**Millennium Coal Mine EPML00819213
Environmental Authority amendment
Information Request Response**

17 February 2025

The Information Request (IR) response provided in **Table 3-1** below is based on the MetRes EA EPML00819213 amendment submission received by the Department of Environment, Tourism, Science and Innovation (DETSI) on 19/06/2024 [Department reference: application number C-EA-100673441].

Figure 1. New Chum Creek and Isaac River catchments

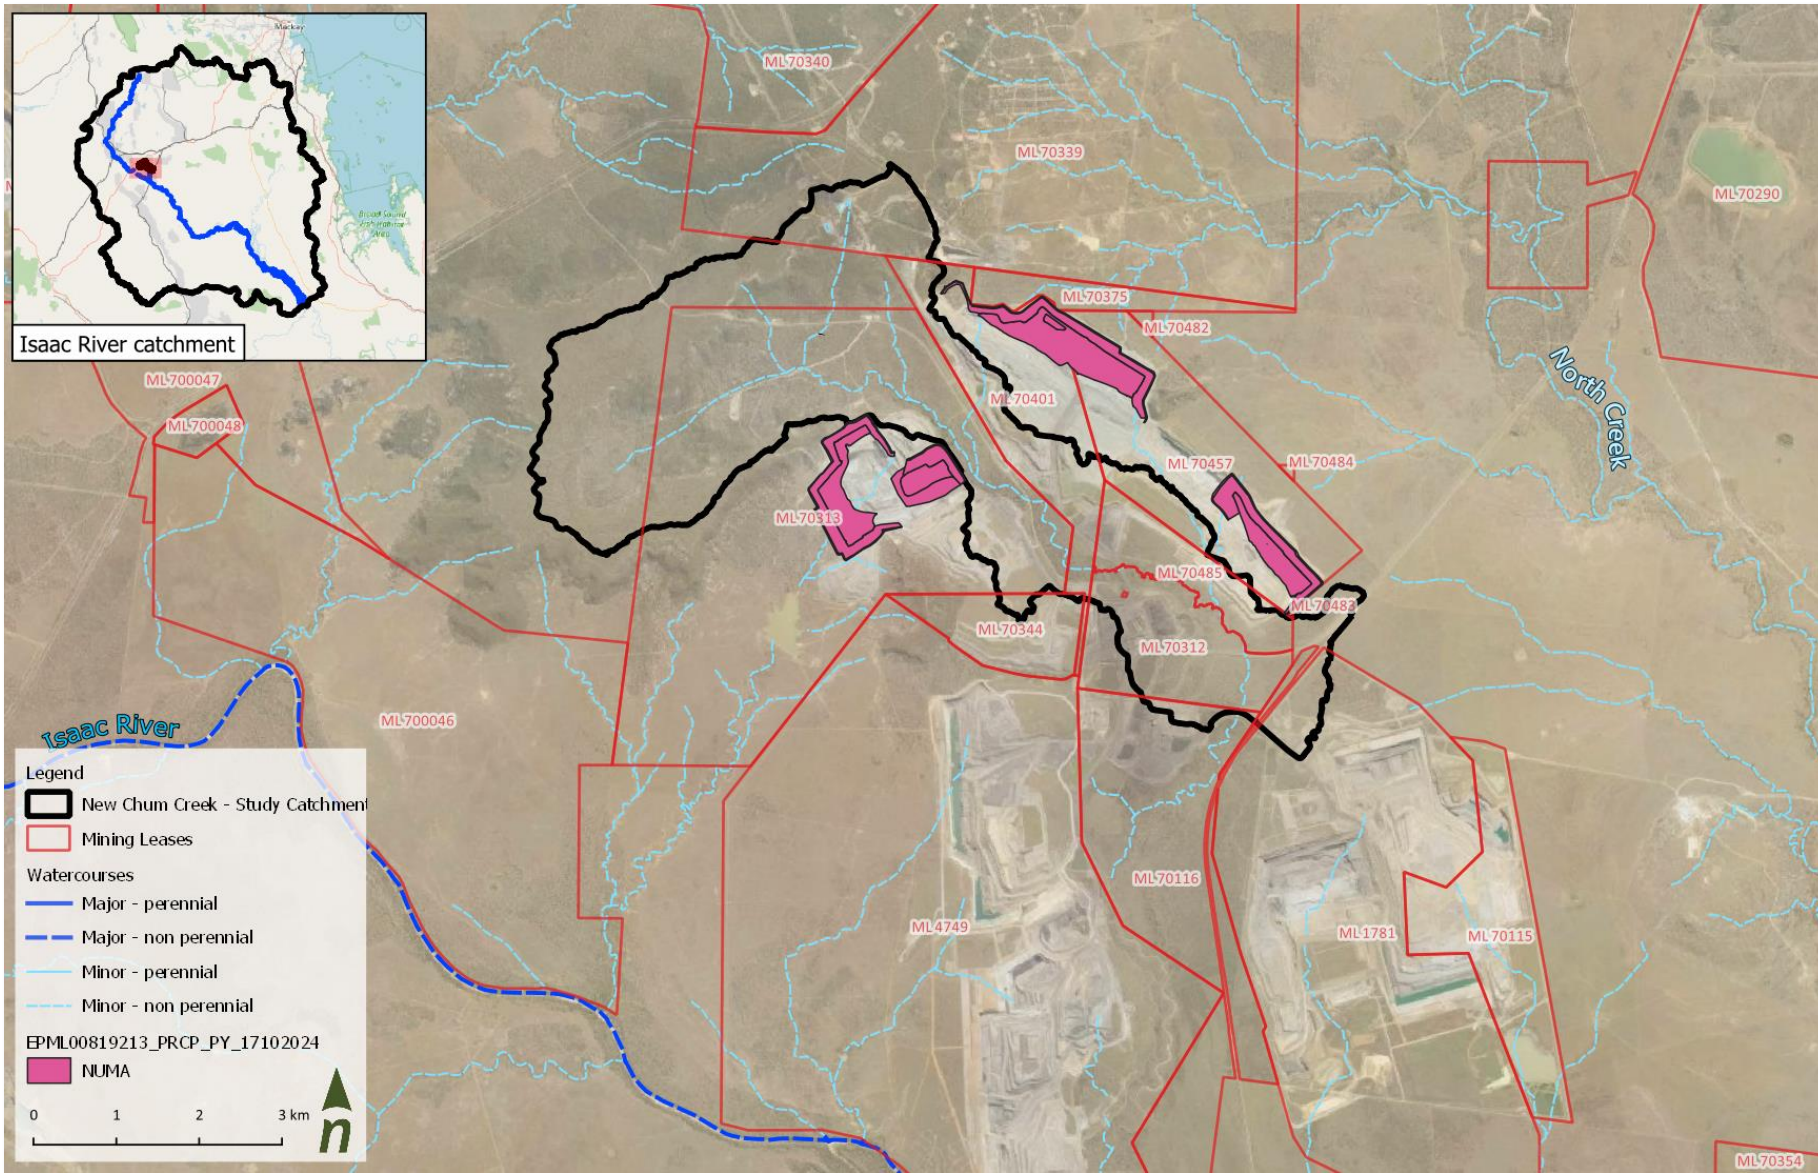
<p>NUMA supporting information</p> <p>Section 5.3 Surface water</p>	<p>NUMA within the catchment to clarify proximity of the proposed NUMA's to the Isaac River/New chum creek which flows through the site.</p> <p>Additionally, the section does not discuss the potential impacts of flood situations, interaction of the flood waters with the residual void waterbodies containing saline waters considering the proximity of the MCM to the New Chum Creek.</p> <p>The EP Act section 226A(f) requires the EA amendment application to include assessment of likely impacts of the proposed amendment on environmental values including description of risk, likely magnitude and management practices to prevent or minimise adverse impacts.</p>	<p>a) Isaac River and New Chum Creek catchment area details.</p>	<p>a The New Chum Creek catchment area with proximity to the NUMA is presented in Attachment E Error! Reference source not found. The catchment assessed is 22.8 km².</p> <p>Based on the PRCP landform, the catchment area of New Chum Creek is anticipated to change by 0.075km² which accounts for 0.3% of the study area and not anticipated to result in any material changes to peak flows or runoff volumes.</p> <p>Sub-catchments have been delineated to provide for appropriate representation of the routing behaviour in the study area. The sub-catchment delineation also aimed to maintain a reasonable ratio (less than 2:1 in general) between catchment length and width ensuring valid catchment routing. Efforts were made to maintain as much consistency as possible in the size of sub-catchments.</p> <p>The initial sub-catchments were delineated primarily based on topographical</p>

The New Chum Creek catchment area with proximity to the NUMA is presented in Figure 1 below. The catchment assessed is 22.8 km².

The Isaac River is the receiving waterway for New Chum Creek however it does not hydraulically impact the subject site and was not considered in this scope of work. The location of the New Chum Creek catchment within the Isaac Creek catchment is shown in the below figure. Detailed discussion of the catchment delineation is provided in **Attachment A** - Section 3.2.

Figure 2 Updated cross-section through Pit A&B and Pit M&D

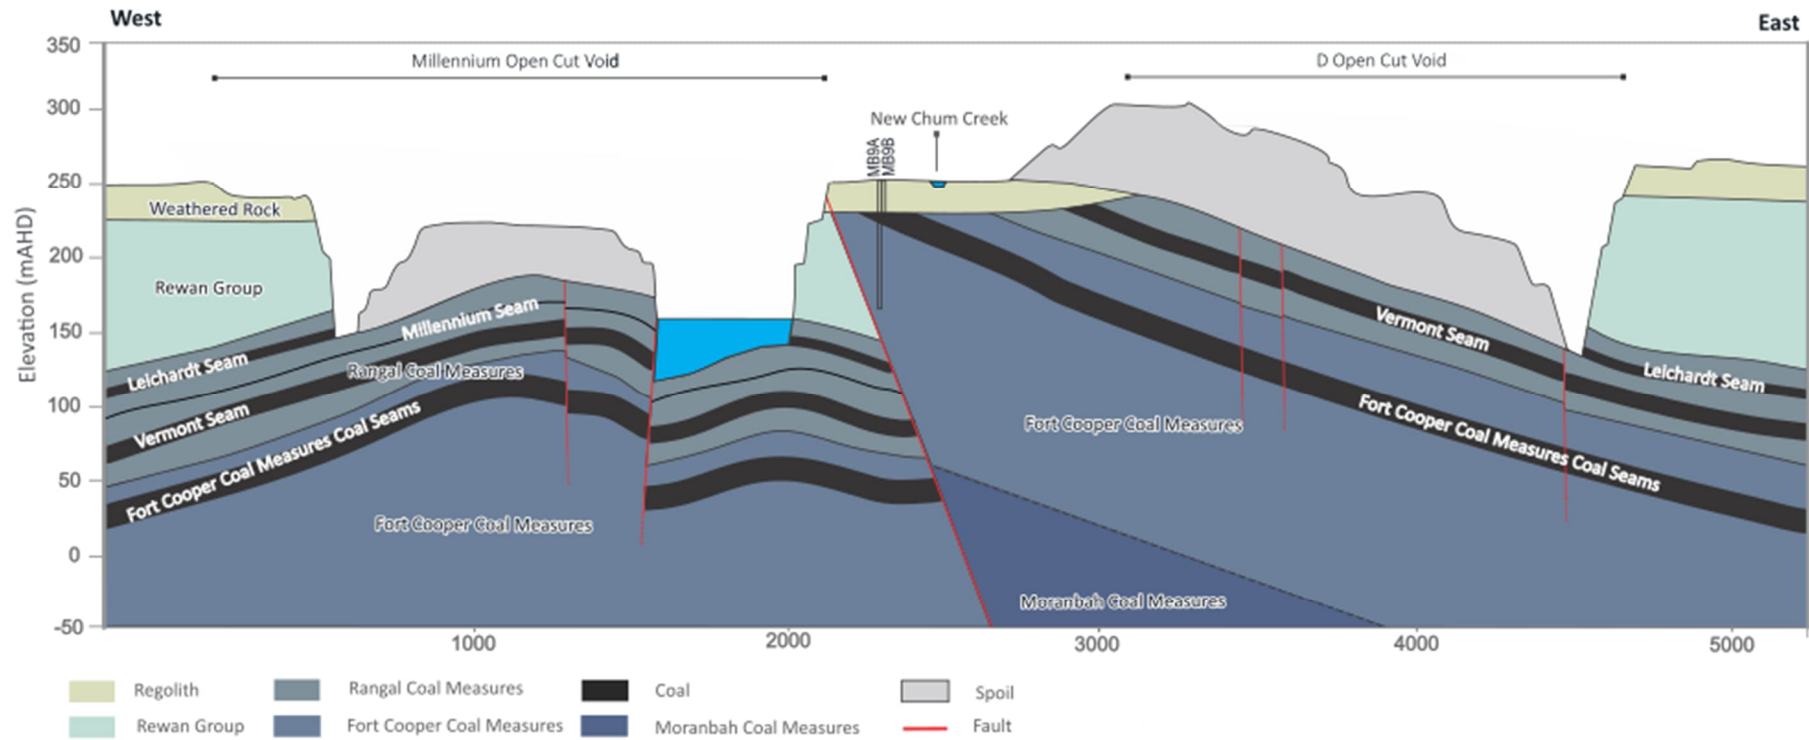
However, Appendix G Figure 3-4 is a cross section showing the locations of Pit A&B and Pit M&D. Pit E is not shown but section 3.2.5 states that: For Pit E the cross section and characteristics are the same as what is observed for Pit M&D.

The Figure 3-4 cross section indicates that the Vermont seam is in the Fort Cooper Coal Measures and that only the Leichardt seam is mined.

The cross section has been updated to reflect the correct nomenclature for the coal seams. The updated cross section is provided in **Figure 2**. An additional cross-section showing Pit E and the Mavis underground mine is provided in **Figure 3**. The Millennium Seam is only present in the Millennium pit south-west of the fault. Leichardt forms the target seam in the open cut-voids and future underground mining. The Vermont Seam is not being mined.

The conceptualisation text, as reproduced in the explanatory text (above) is correct, and the amended cross-sections now represent this description.

Figure 3 Cross section through Pit E and Mavis underground

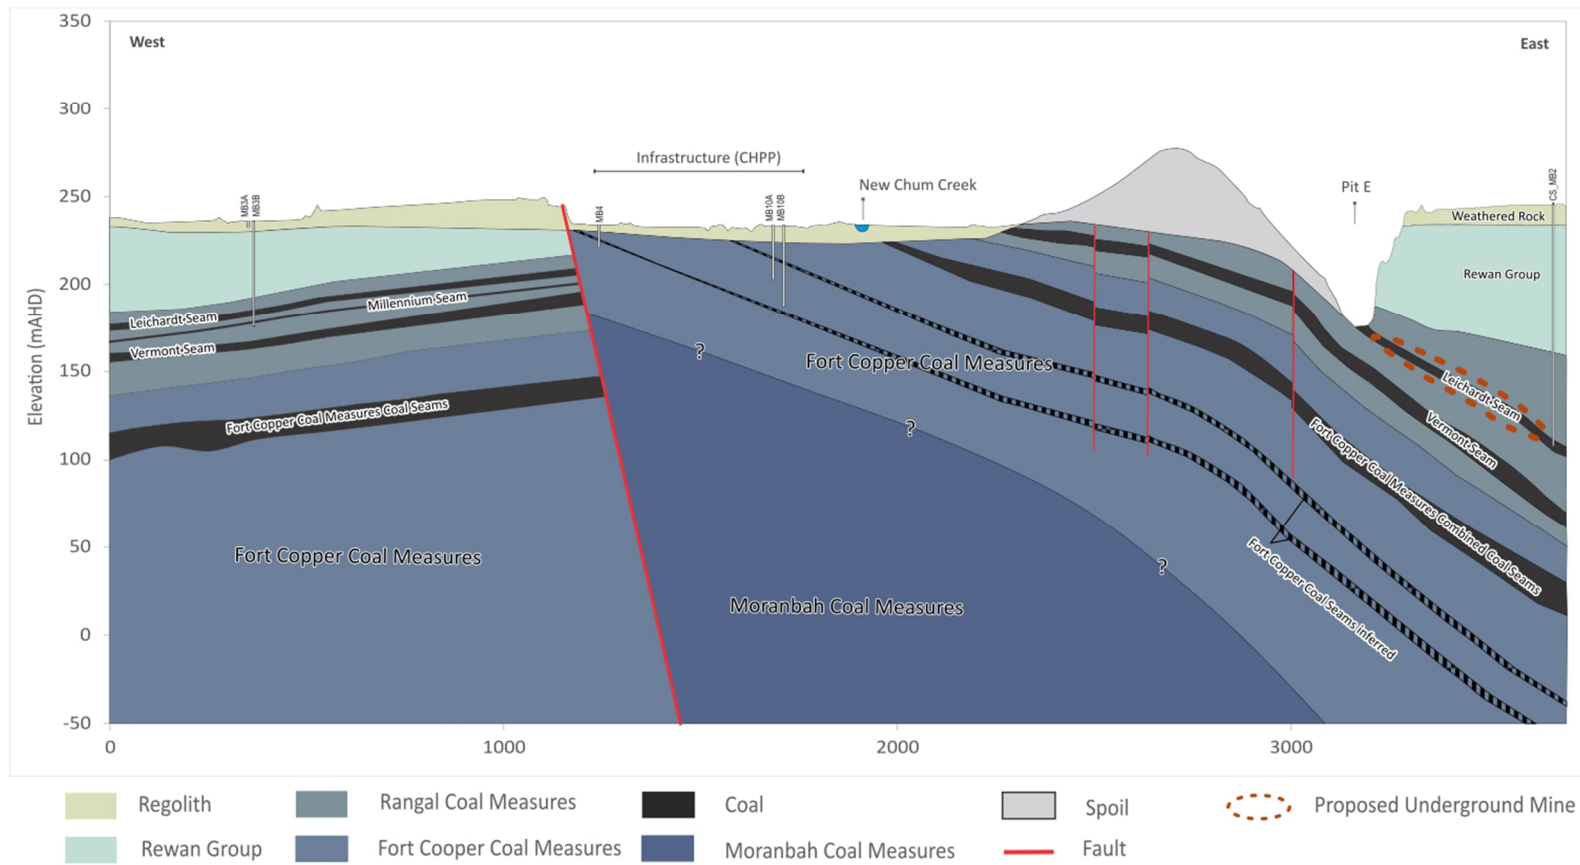
Additionally, it is noted on Figure 4-8 that there is similarity between the groundwater levels in MB3B and MB4. MB4 is identified in Table 4-2 as a Tertiary Sandstone bore screened between 29m and 35m.

- a) A review of the monitoring network, including screened interval, has been undertaken. The three bores in question (MB3A, MB3B and MB4) are presented on the cross-section provided in **Figure 3**. The logs and cross-sectional interpretation both indicate that MB3A is screening the regolith and both MB3B and MB4B are screening the overburden of the Fort Cooper Coal Measures. The logs for MB3A, MB3B and MB4B are provided in **Appendix A**.
- b) The aquifer reference for these bores has been updated in relevant databased and will be included as such going forward.
- c) The inclusion of MB3B and MB4B into the Tertiary Sandstone, rather than the Fort Cooper Coal Measures at the time of initial modelling was not deterministic to the overall model outcomes. The Tertiary Sandstone is proximal to Millenium Mine as isolated deposits occurring along New Chum Creek.

Figure 5 Conceptual cross section for void interaction with portal (left) and remaining length of E pit (right)

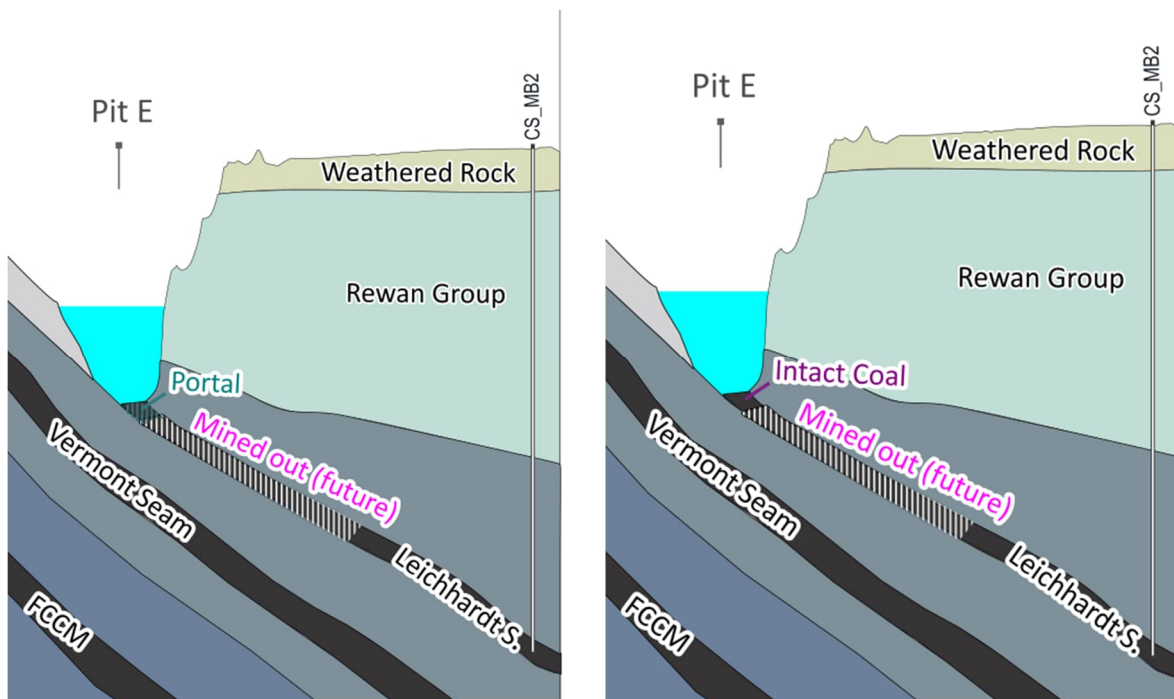
When the underground mining occurs, the coal seam is partially mined out by the bord and pillar method (mined out area presented in **Figure 5**). In the groundwater model, this was reflected by changing the material properties of the coal seam in the area that was mined out to a storage coefficient of 50% (50% is now a void and 50% is remaining coal) and an increase in hydraulic conductivity. This approach was also applied to the portal. The implication on the modelling result of the missing portal seal is that the exchange between void lake and coal seam is locally overestimated, i.e. the model shows a higher exchange than it would be in reality at this location.

In response to IR a) and b), please see **Figure 5** presenting a conceptual cross section (refined detail of **Figure 3**). On the left-hand side, the section goes through the portal area, which is approximately 10% of the E pit length. The full length of the E Pit is 1500m. Where

However, the portal area is only a small proportion of the entire E Pit length. Additional interaction between the Leichardt Seam and the void is expected along the full length, given the coal seams are deemed the most permeable formations at this depth. There is a strip of intact coal (i.e. not mined) between the border of the open cut pit and the mined out underground area (**Figure 5**). There is limited flow expected through that interface along the entire void area. Adding the seal to the portal cells in the groundwater model would not change the water interactions significantly. It is also noteworthy that all water in the recovered case is flowing from the outside into the void and the amounts of groundwater inflow are insignificant compared to the surface water inflows to the void.

In summary, the modelling approach for the portal is not likely to have any impacts on the results.

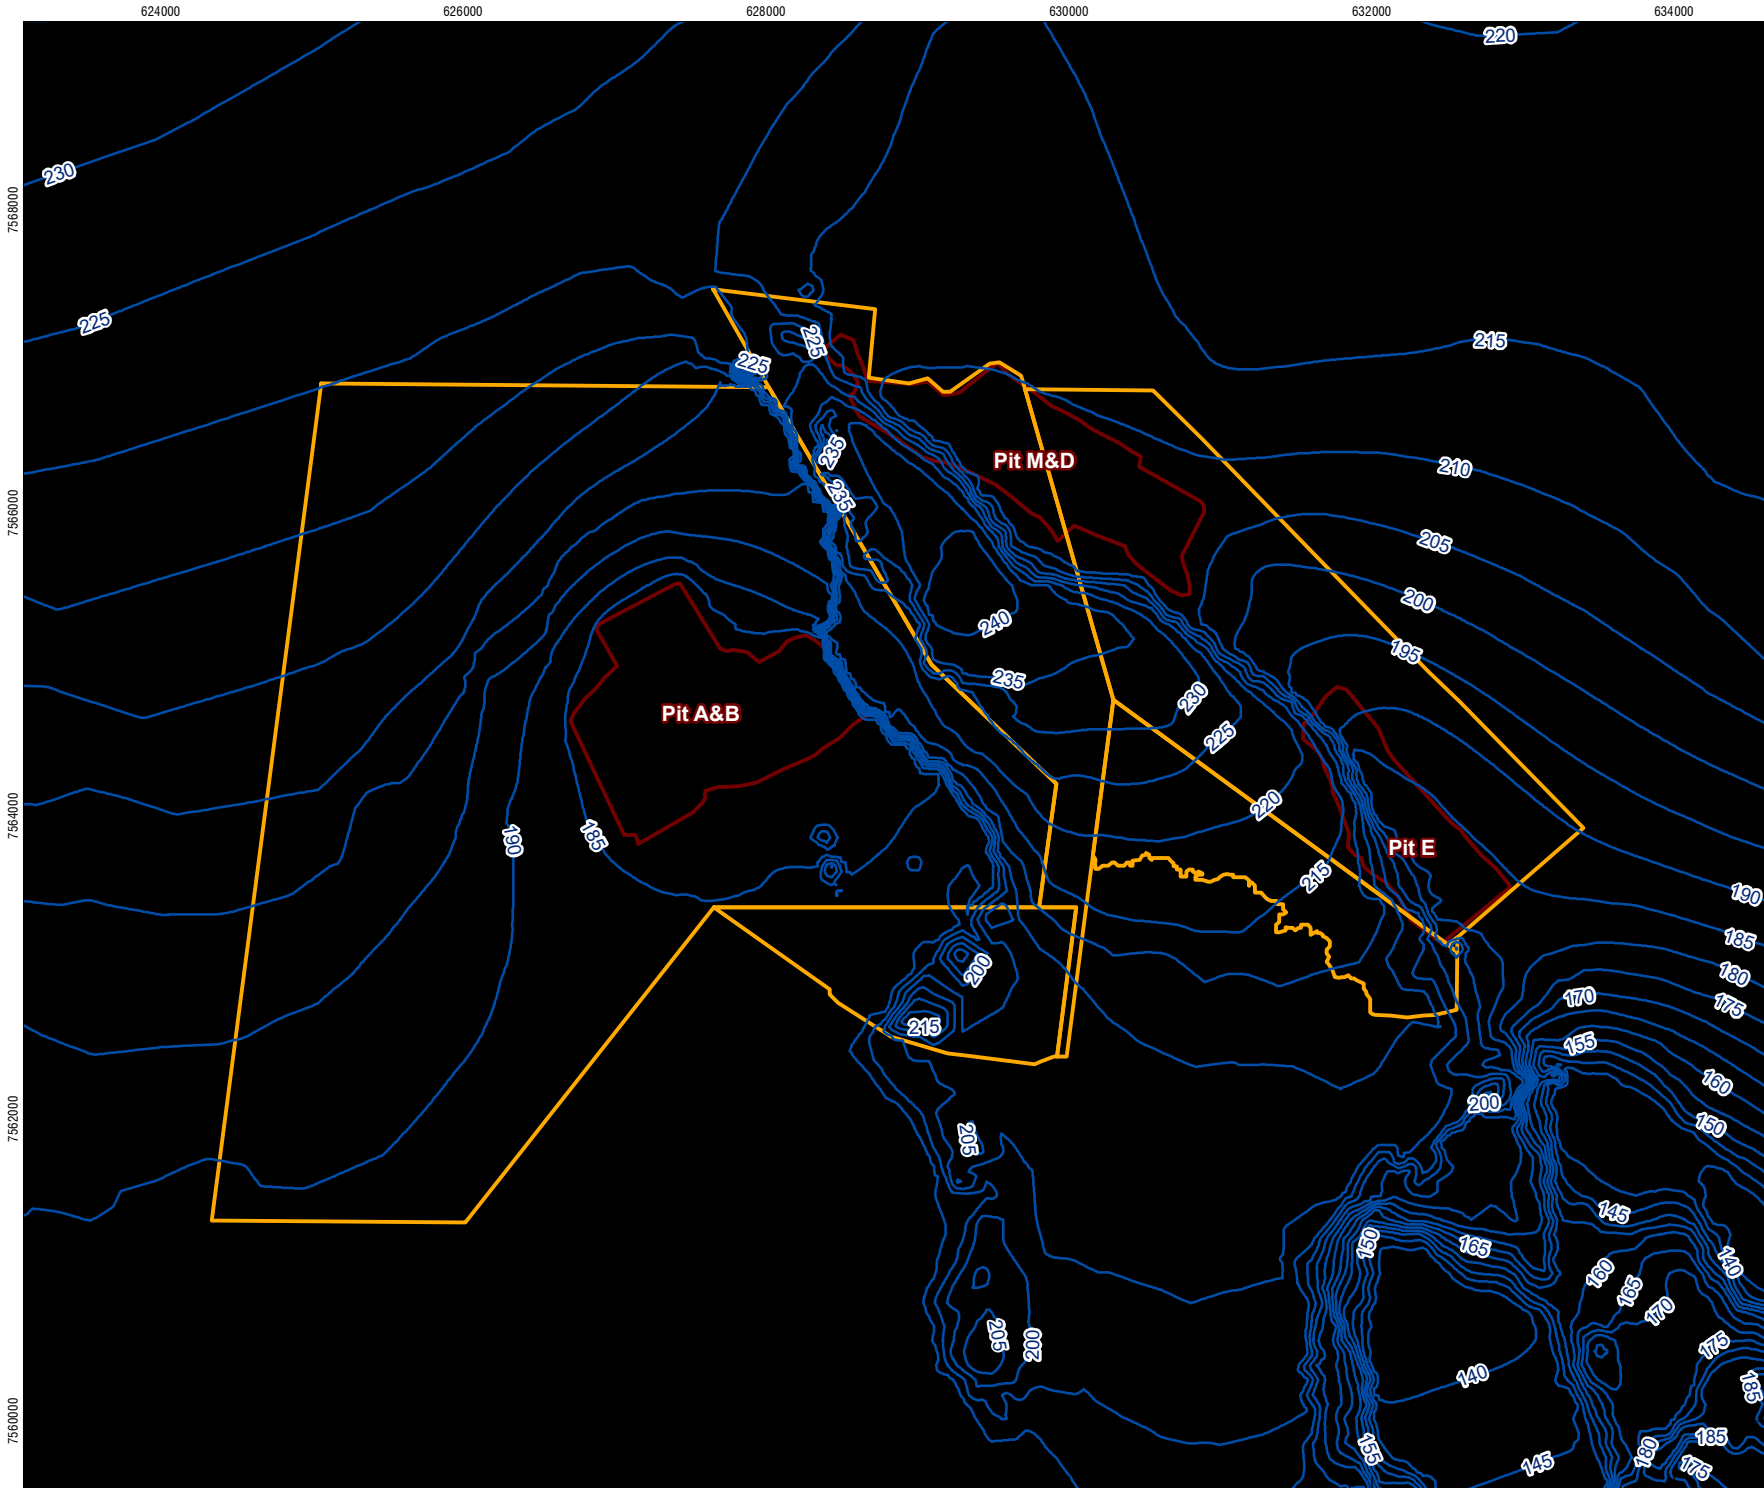
The sink behaviour of all three voids is clearly demonstrated in Figure 6-14 as the capture of water particles in the mining-affected layers in the voids is evident in the results of the modPATH3DU particle tracking simulation. It should be noted that the particles placed along the southern edge of the E-pit area and underground mine extension that leave the Millennium/Mavis Open-Cut area are drawn towards the Daunia mine Titan voids which are also groundwater sinks in the current model set-up. The particle on the western edge of the waste rock dump which leaves the Millennium area and migrates south along the edge of the Poitrel mine area remains within the Rewan group, as its final location is within model layer 3 (Rewan Triassic unit). It is also anticipated that if the Poitrel closure plan were completely implemented in the model with CHDs assigned based on a surface water model, the Poitrel voids should act as sinks and potentially trap this particle as was observed with the Daunia voids to the east.

Figure 6-13 of the PRCP Appendix G was replicated here as **Figure 10**. Instead of showing the particle's layer as they move along the path line, the path lines were coloured per their fate. The aqua colour relates to particles captured by a final void. The pink colour relates to particles that represent regional groundwater flow or particles that are still travelling by the end of the model run (i.e. slow-moving particles that have not yet reached the void as their final destination).
